East Reading Mass Rapid Transit Route

Scheme Amendments

The application was first submitted on 4th July 2017. Since then, the scheme has been amended and improved to take account of various comments and feedback from consultees (including local communities) and by WBC and RBC planning officers. The amended scheme was formally submitted on 27th April 2018. These amendments included:

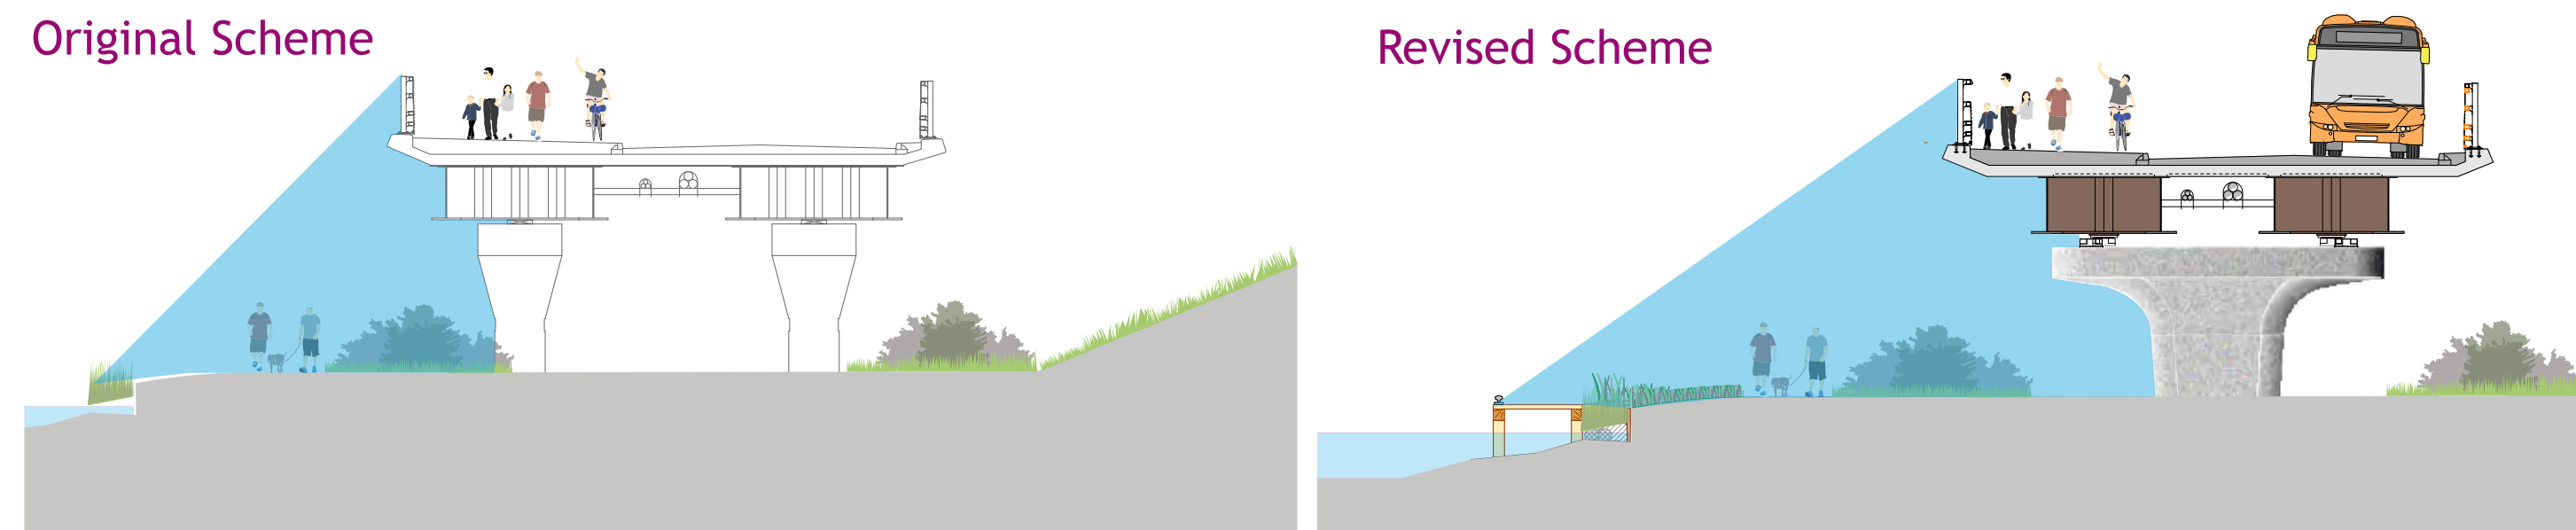
3. Reduced Columns

The originally submitted viaduct scheme was supported by a row of two columns. This has been reduced to a single column along the length of the viaduct east of the River Kennet. The single column design is considered to be more elegant and reduces the footprint, compared to the original two-column design. It also helps to create an increased sense of openness for towpath users.

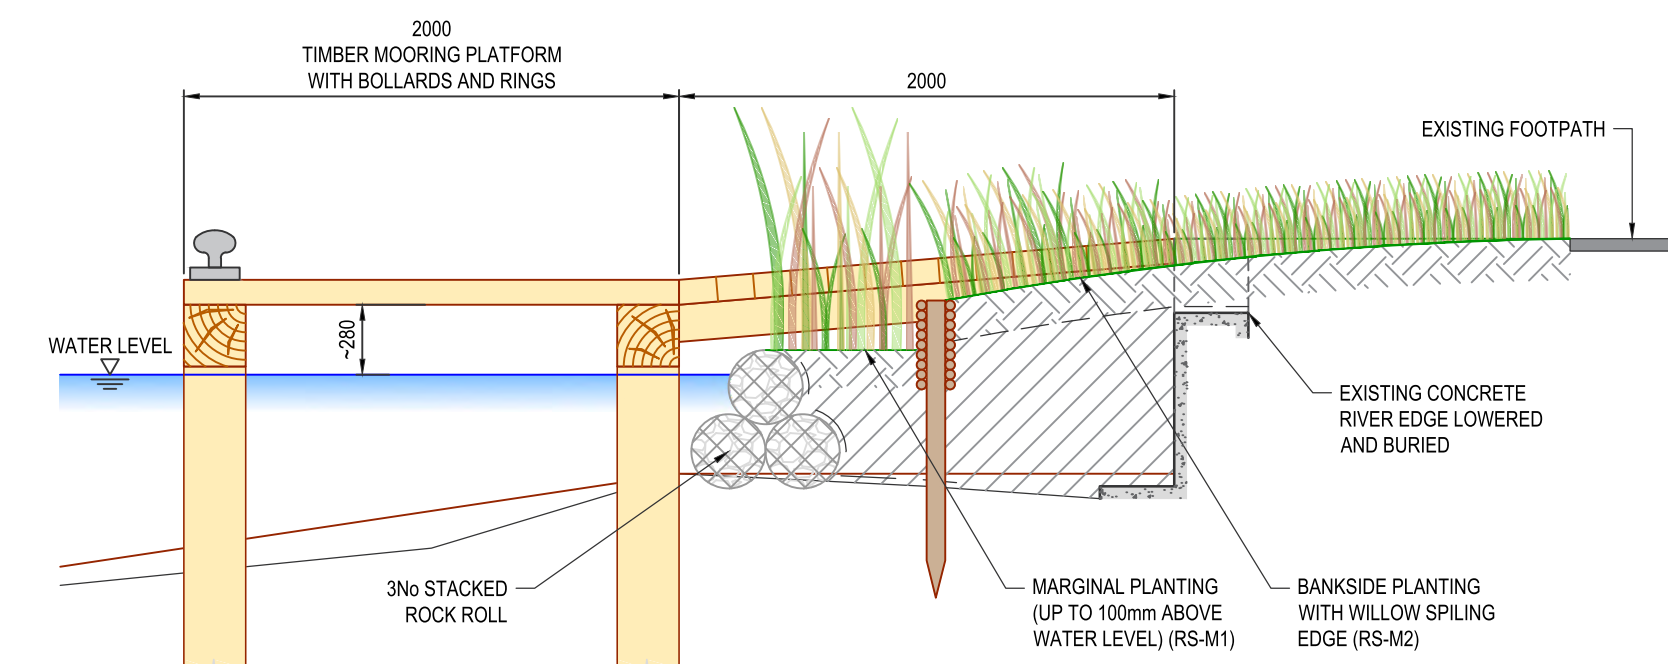
8. Under Viaduct Enhancement

Beneath the viaduct, areas of marshy wetland and grasses will be created, providing an area for seasonal flooding, and a diverse marshy habitat, which includes the locally-occurring Loddon Lily. The area under the viaduct is proposed to remain open and unfenced to allow people to see beneath the viaduct, whilst discouraging public access. Provision is made within the amended proposals for the potential for fencing to be installed beneath the viaduct at a later date, if proven to be desirable. We have responded to earlier feedback by removing the original proposals for green panels, 'feding' and reclaimed boats. There is opportunity for the local community and schools to be involved in the design of storyboards, the reinstallation of the mosaic and the planting of Loddon Lily / marsh plant species beneath the viaduct.
